CHEVROLET—CENTRAL OFFICE

TECHNICAL SERVICE BULLETIN

RELOCATION AND REVISED OIL PRESSURE
SUBJECT: SENDING SWITCH - 1961-62 CORVAIR
AND CORVAIR "95" MODELS

BULLETIN NO. DR #538

FIGURE I

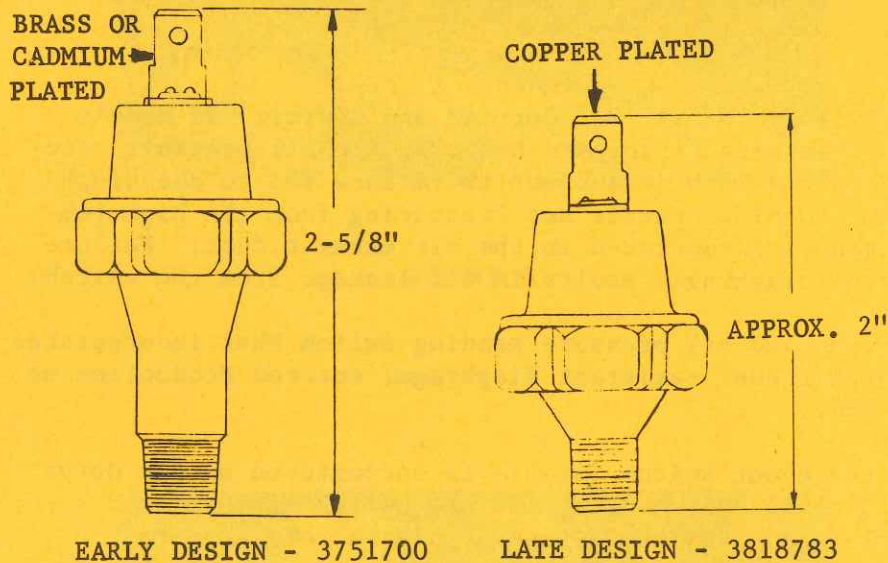
The new switch Part No. 3818783, has an overall length of approximately 2" from connector tip to the end of the threads as shown in Figure 1. The connector terminal is copper plated as an additional means of identification.

An early design oil pressure switch as shown in Figure 1, with an overall length of 2 5/8", was used on all Corvair and Corvair "95" engines built prior to 8/31/61, except vehicles equipped with air conditioning. Vehicles equipped with air conditioning used an interim switch which has the same overall length as the late design switch, except the connector terminal is brass or cadmium plated. This switch was also used on all Corvair and Corvair "95" engines built from 8/31/61 to 11/8/61.

FIGURE 2.

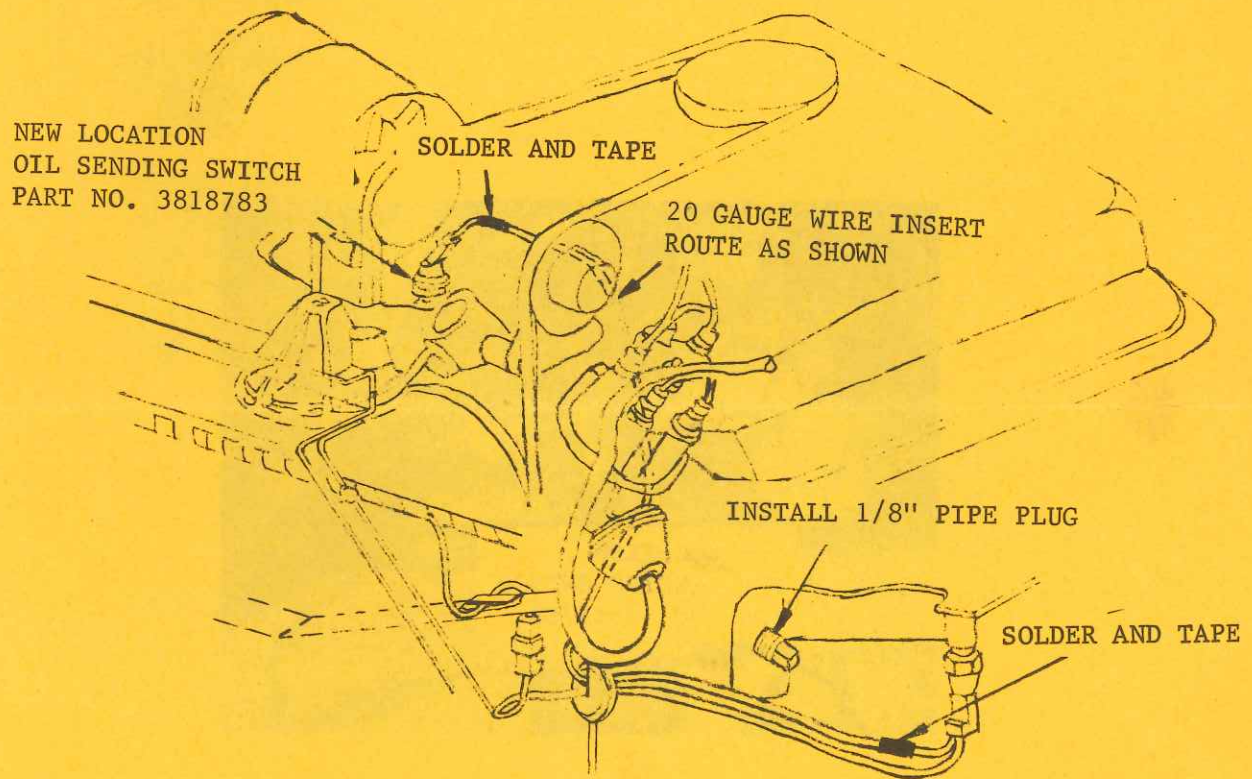
1. Rework the existing rear extension wiring harness by cutting the wire between the oil pressure and temperature sending switches and lengthening it to 19" overall with a spliced insert of 20 gauge standard plastic insulated wire similar to the existing wire. Solder and tape both joints and route wire as shown in Figure 2.
2. Remove existing 1/8" pipe plug from top of oil filter adapter assembly with reference to Figure 3, and install it in the hole formerly occupied by the oil pressure sending switch, using suitable sealer on threads.

FIGURE 4

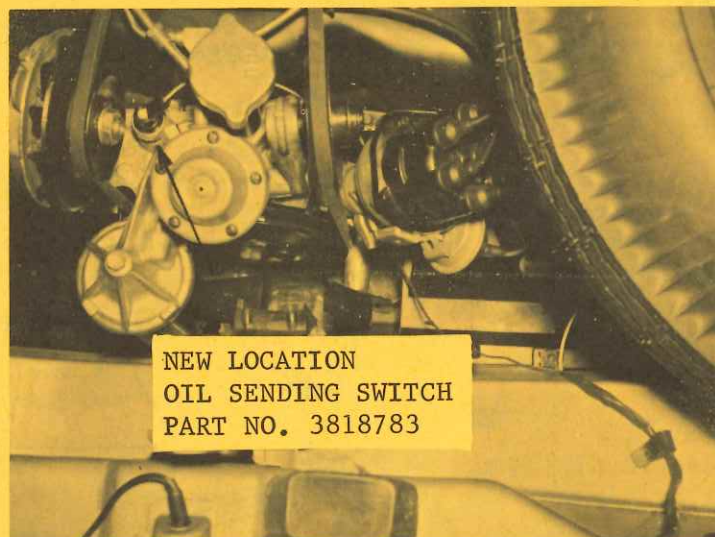
3. Install new switch, Part No. 3818783 in the oil filter adapter assembly as shown in Figure 4. Torque switch to 8-12 ft./lbs.

CAUTION: Use a 1 1/16" 6 point socket to install the switch. The use of pliers or even a 12 point socket may distort the switch housing resulting in subsequent switch failure.
